HOWARD COUNTY HISTORIC PRESERVATION COMMISSION

September Minutes

Thursday, September 7, 2017; 7:00 p.m.

Figure 2 - Proposed location of solar panels. The blue line is the boundary of the Lawyers Hill Historic District.

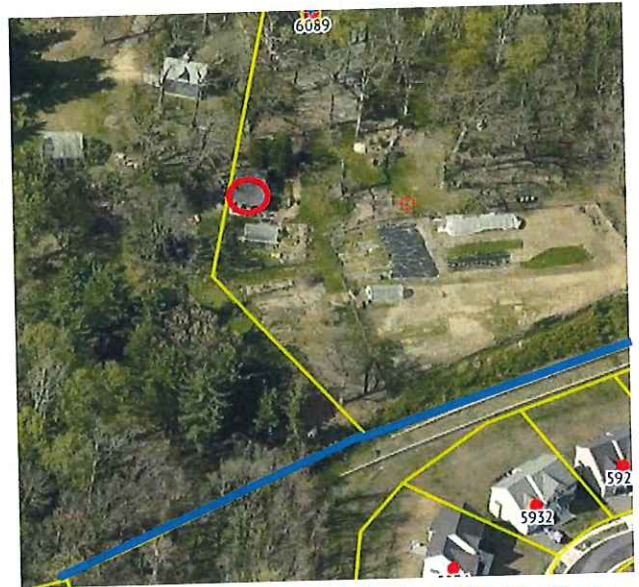
Applicant proposes to install sixteen 40"x60" solar panels to the roof of the modern overhang, which is on the rear of the barn and faces away from Lawyers Hill Road. The panels will have a black anodized aluminum frame and will be flush mounted with a 10-degree tilt. The existing roof of the garage/barn is gray asphalt shingles.

The barn is located approximately 600 feet away from Lawyers Hill Road, will not be visible from the street, and will face the adjacent community that is not within the historic district.

Staff Comments: The application complies with the Guidelines for the Use of Solar Panels, "add solar panels on a roof not visible from a public way" and "place solar panels or other solar devices on roofs on a non-character defining roofline of non-primary elevation (not readily visible from public street)." The solar panels will be added to the rear of a non-historic building and will not be visible from a public street. While there is a neighboring historic property in close proximity, the solar panels will face away from that property and should not be visible.

Motion: Mr. Reich moved to approve the application as submitted. Ms. Tennor seconded. The motion was unanimously approved.

Figure 10 - Proposed east (side) elevation

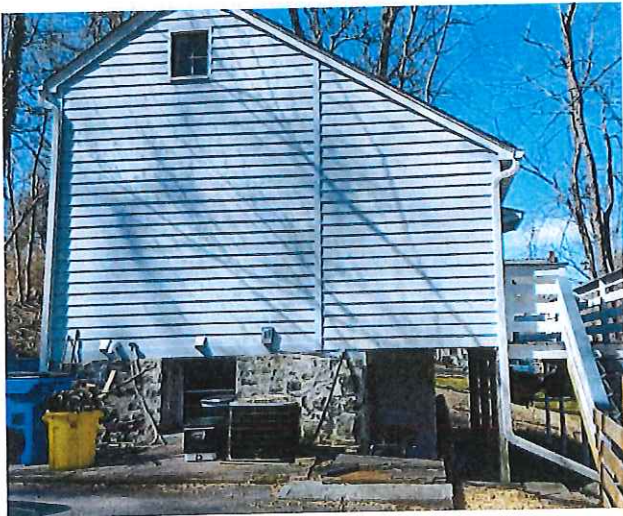
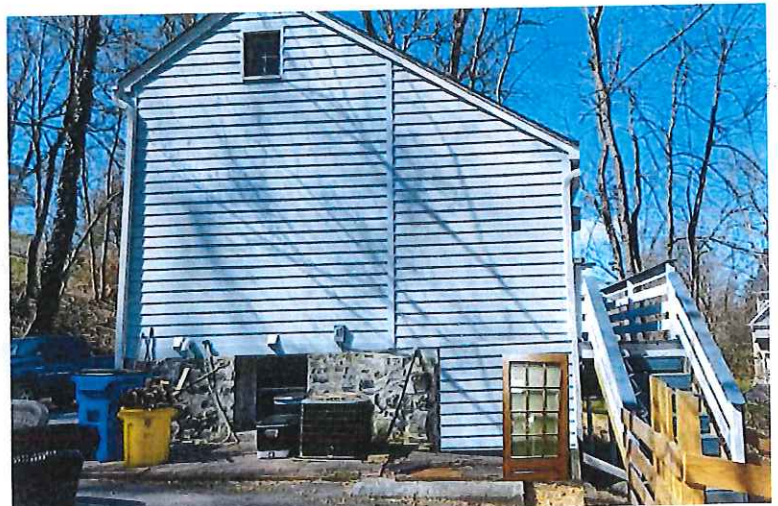
Staff Comments: The addition will be located on the rear of the structure, which complies with Chapter 7.1 recommendations, “attach additions to the side or rear of a historic building to avoid altering the primary façade. Consider the impact of the addition on side, rear and rooftop views of the building from a public way.” The house is located at the end of Ross Road, which is not a through street and ends by this property. The rear of the house backs up to properties located on Mulligans Hill Lane (Mulligans Hill also dead ends near this property). As such, the rear of the house is not visible from the public way.

Chapter 7.1 states, “design additions in a manner that makes clear what is historic and what is new. Additions may be contemporary in design or may reference design motifs from the historic building, but should not directly imitate the historic building.” Chapter 7.4 also states, “design windows to be similar in size, proportion and arrangement to the existing windows. On historic buildings, or any building visible from a public way, windows should have true divided lights rather than interior or sandwiched muntins. A possible alternative is windows that do not have divided lights, but have permanent exterior grilles, appropriately detailed to be compatible with historic wood windows.” The design of the addition is more contemporary on the rear of the addition than on the sides. On the sides of the addition, which will be visible from the public right of way, the Applicant proposes to use a 12-lite wood door. For the rear of the structure/addition, the Applicant proposes to use a full lite door and 1:1 windows. The Guidelines indicate this may be acceptable, but it would be more consistent to install the 12-lite wood door on the rear and a simulated divided lite window with exterior muntins on the rear, which would keep a consistency in design throughout the house and addition. The Marvin Integrity windows do come in two styles of a simulated divided lite, as shown in Figure 11. The addition will be constructed with HardiePlank, which will make clear that the addition is not a historic addition, but a modern one.

Chapter 7.5 states, “on any building, use exterior materials and colors similar to or compatible with the texture and color of those on the existing building. Avoid exact replication that would make an addition appear to be an original part of a historic building.” The use of the modern window material is acceptable for a rear addition that is not visible from the public right of way. The proposed 12-lite door is a wood door, which best complies with the Guidelines. Staff recommends the Applicant use a smooth textured HardiePlank siding as opposed to the Cedarmill, as painted wood siding does not have a texture. The Cedarmill siding does not comply with the Guidelines. The difference in materials between the historic wood siding and the new HardiePlank, will suffice in avoiding exact replication, but the textures should be similar, as recommended by the Guidelines.

Ms. Zoren said the Applicant should consider the side elevation as if she were to stand in the room and what her viewpoint would be like. There will be 12 lite doors on the sides and full panel glass doors in the same room that may throw off the uniformity internally. Ms. Lyon said without the grills, it allows the original stone foundation to be more visible looking from outside.

Ms. Zoren said the proportion of the four by five windows are very horizontal compared to vertical windows on the rest of the house. She suggested that the Applicant add three more vertical windows in the space where the two windows are, which would result in better symmetry. Ms. Lyon said there are structural columns there, preventing a different window arrangement.

- 1) The siding should be changed to a smooth textured HardiePlank.
- 2) The windows have external simulated divided lites.
- 3) The 12-lite door be used for all doors on the addition.
- 4) A spec sheet and location plan needs to be submitted and reviewed for the exterior lights.
- 5) The deck remains the full width of the house.

Motion: Mr. Reich moved to approve the application as submitted allowing the Applicant to use: either smooth or textured HardiePlank siding; either divided or undivided lite for the rear windows; and the twelve lite divided doors on the exposed end walls. The location of the exterior lights to be approved as submitted. The deck is approved as submitted as an exit from the second floor. Ms. Tennor seconded. The motion was unanimously approved.

Figure 13 - Proposed sign

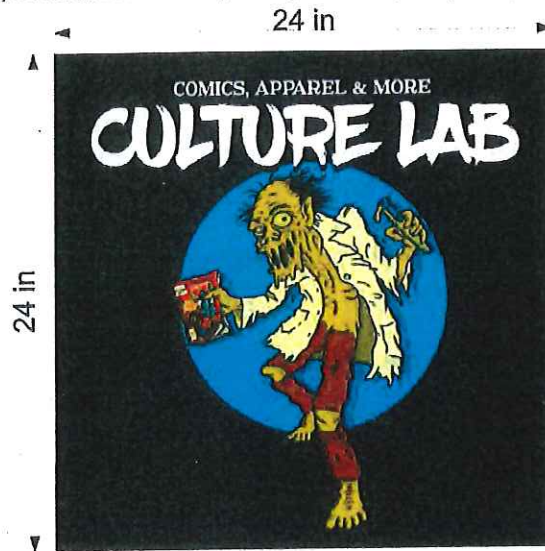
Staff Comments: The application does not comply with the recommendations in the Guidelines, which state, "use a minimum number of colors, generally no more than three." There are approximately 7 to 8 different colors and shades within this sign.

While the application states, "the size and style is very similar to other Main Street businesses and has no more color or variation than existing signage on the street," Staff is unable to find other comparable signs that the Commission has approved. The majority of the signs on Main Street are limited to the business name, with a small graphic detail. Aside from the color, the size of the sign complies with Chapter 11.B recommendations, "limit the sign area to be in scale with the building. Projecting or hanging signs of four to six square feet are appropriate for many of Ellicott City's small, attached commercial buildings."

Chapter 11.A of the Guidelines recommends, "keep letters to a minimum and the message brief and to the point. In many cases, symbols or illustrations that communicate the nature of the business can be used" and "emphasize the identification of the establishment rather than an advertising message on the face of the sign." The proposed sign does have a small tagline of "comics, apparel and more" which is brief and to the point and is a minimal advertising message. However, Staff recommends moving that tagline below the business name, so that the business name remains the most prominent item on the sign.

Ms. Zoren said the Guidelines state a maximum of two or three colors should be used per sign. She recommends the proposed logo have a simplified color pallet and that a border be added to the sign.

Mr. Taylor referenced the Guidelines that state a sign should have maximum of two to three colors, and use a simple logo instead of text. Mr. Stringer asked if black and white count as colors. Ms. Zoren said yes, and added that the sign could be black, white and blue for example. Mr. Taylor said the Manor Hill sign is a good example of a sign that fits within the Guidelines. Mr. Taylor said one recommendation is to use simple legible words and graphics, which Ms. Tennor said the Applicant has done.

Staff Recommendation: Staff recommends Approval of a sign to consist of the business name and tagline, using the existing metal hardware. A border should be added around any approved sign.

Mr. Reich said the logo design is good, but the color pallet needs to be simplified and finalized by the Applicant. Once this is done, the Applicant can use the Minor Alterations process for approval.

Figure 15 - Proposed interpretive signage

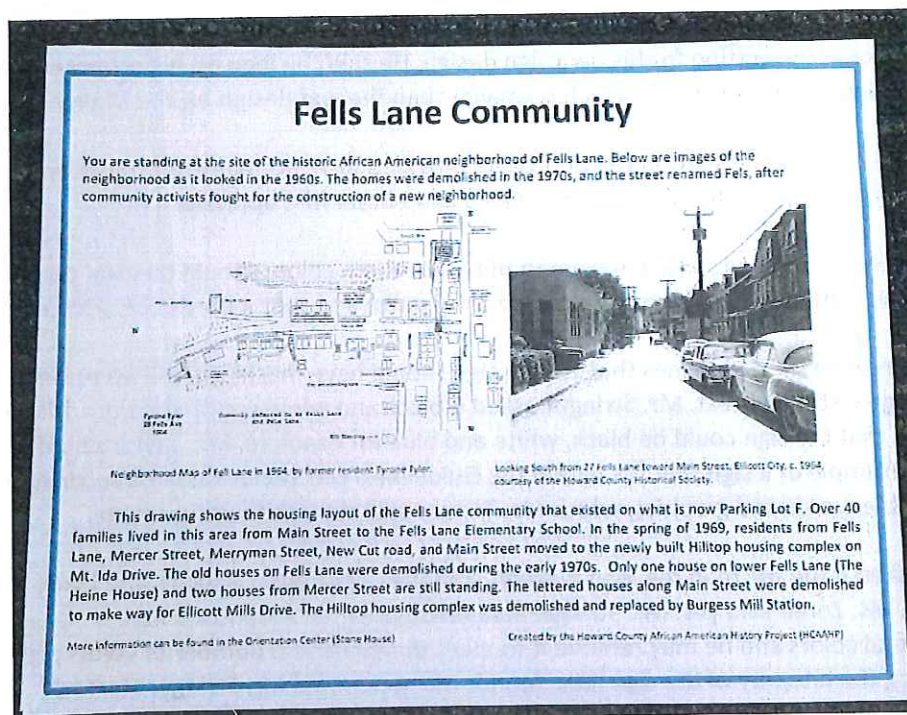
Staff Comments: As mentioned last month when the Applicant filed a similar application, Staff has requested that a new interpretative sign pedestal mount/base be identified for use throughout town through the Ellicott City Master Plan process. However, at this time, the proposed interpretative sign complies with Chapter 10.C recommendations, “use street furniture that is simple in design and constructed of traditional materials such as wood and dark metal” and “improve consistency in design throughout the historic district for items such as street lights, traffic signals, trash receptacles and other street furniture.” The Guidelines also state, “carefully evaluate the need for placing additional street furniture on narrow historic district streets and sidewalks.” The sign will be placed along Ellicott Mills Drive, so additional streetscape items are not being added to crowded Main Street sidewalks. The sign will not block views of the historic structures (the original Courthouse and the Thomas Isaac Log Cabin), but will overlook them from a slight distance and different elevation.

The layout of the sign is clear, easy to read and uncluttered. However, the addition of a neutral colored background color may make the graphics more prominent.

Ms. Tennor asked if the proportions of the sign will increase to include the sponsors’ logos. Mr. Lilley said yes, the sign will be wider, matching the existing Civil War Trails sign. Ms. Tennor said the title of “Fells Lane Community” should be larger to fill the sign space.

Staff Recommendation: Staff recommends Approval as submitted, with the contingency that the sign hardware/holder be replaced when a new standard for town is identified through the master plan process.

Motion: Ms. Tennor moved to approve the application with the inclusion of the partner logos as described by the Applicant. Mr. Reich seconded. The motion was unanimously approved.

Figure 17 - Proposed partner logos

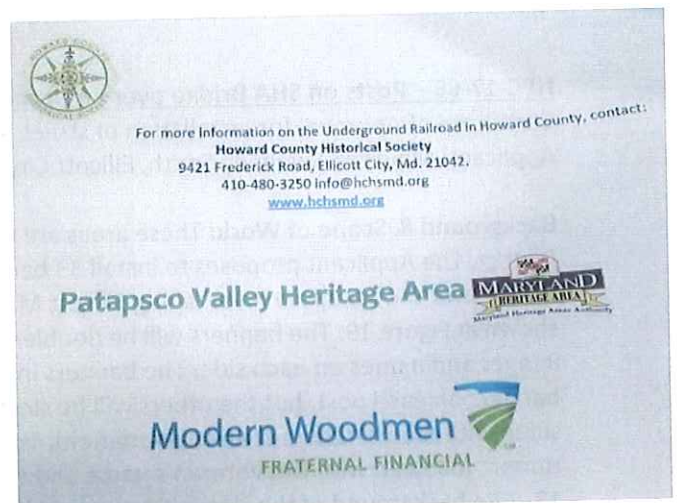
Testimony: Mr. Shad swore in Ed Lilley. Mr. Shad asked if there were any additions or corrections to the Staff comments or application. Mr. Lilley said he did not bring a sample sign incorporating the sponsors’ logos. However, the design will follow the format of previously approved signs like the Underground Railroad Network sign and Civil War Trails signs that feature sponsors’ logos on the right side of the sign, if one was facing the sign.

Figure 20 - Elevations showing repair work

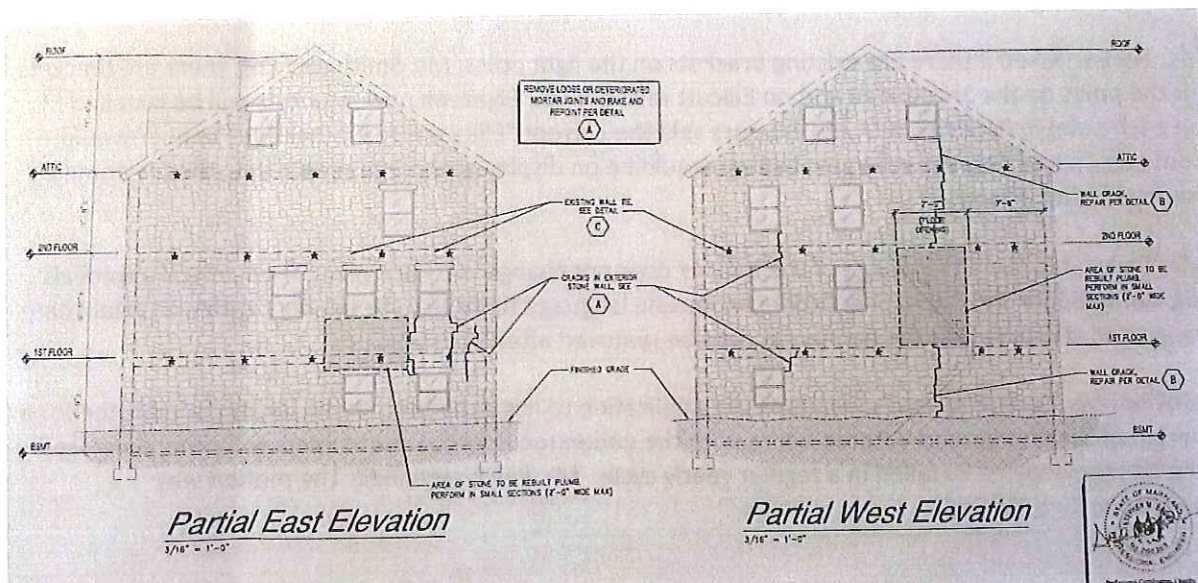
Staff requested additional information on the structural star system, and the Applicant stated they were recommended by the structural engineer, provided a photo of the stars and provided elevations showing the area the stars will be added and the area where the walls will be rebuilt. Staff would like more information on how the structural star system will be installed in the house and what the system will do. The metal rod system associated with the structural stars is somewhat shown in the drawings provided, but a more a detailed explanation of how this system works is needed.

Ms. Tennor asked about the materials in the cracked stone wall. Mr. Shapiro said it is mortar but the previous owner repaired the walls with cement, which is not appropriate. The Applicant's mason said if water seeps in and freezes, the material would pop out because there is no space for expansion. Mr. Shapiro said he planned on doing 50% repoint, but with the installation of stars, it seems 100% repoint may be needed.

Figure 21 - Proposed rain gardens

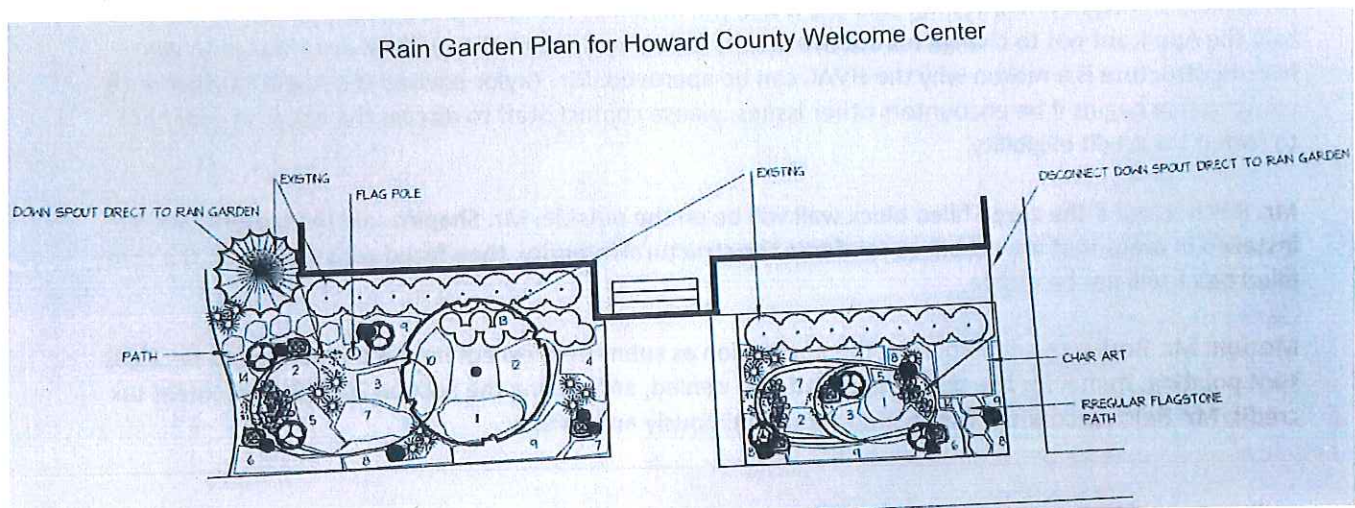
Initially Staff was concerned at the potential height of the plantings as aster and solidago exceed 3 feet, if not 4 feet, in height when mature, but the Applicant has confirmed that dwarf varieties were chosen. The Applicant has also indicated they are flexible with the proposed plantings. Staff was also concerned about the ability to access the downspout by the ADA ramp, but the Applicant has confirmed a contractor stated they will be able to access this downspout for the rain garden, without disrupting use of the ramp.

Chapter 9.B states, "locate, drain and maintain landscape planters to minimize moisture retention that could damage the siding and foundation of adjacent buildings." While the rain garden should not affect the foundation of this building, Staff recommends the contractor confirm that the proposed rain garden would not have a detrimental effect on the structural integrity of the building.

Staff Recommendation: Staff recommends Approval of the rain garden, but recommends a more formal planting scheme be identified in order to protect the historic and architectural integrity of the structure and that the plantings not exceed three feet in mature height. Staff recommends approval of the current art, but recommends the location be moved to the east garden location. Staff recommends the interpretative displays be resubmitted at a later date after Staff has been able to identify a new standard style for use throughout town.
